V8 Service Long Block Kits 8M0142279 and 8M0142280

Models Covered	Serial Number
V8 AMS and V8 CMS engines	3B056352 and Below

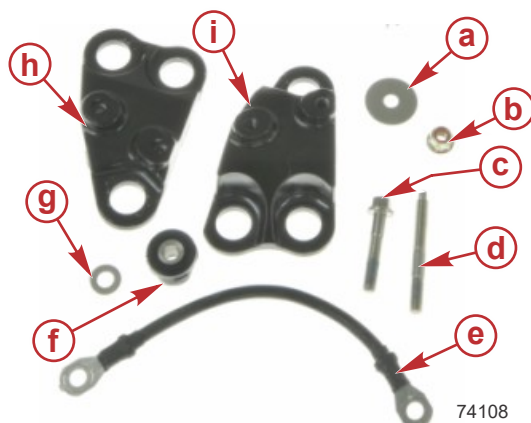
Original V8 AMS and V8 CMS engines 3B056352 and below use a rubber dampener flywheel. Service long block kits 8M0142279 and 8M0142280 include a solid flywheel.

Rubber dampener flywheel

Solid flywheel

When servicing a V8 AMS or V8 CMS engine 3B056352 and below with a new long block kit that includes a solid flywheel, you must install the rubber isolated alternator mount kit 8M0188844. Failure to change the mounts will cause excessive vibration to the alternator.
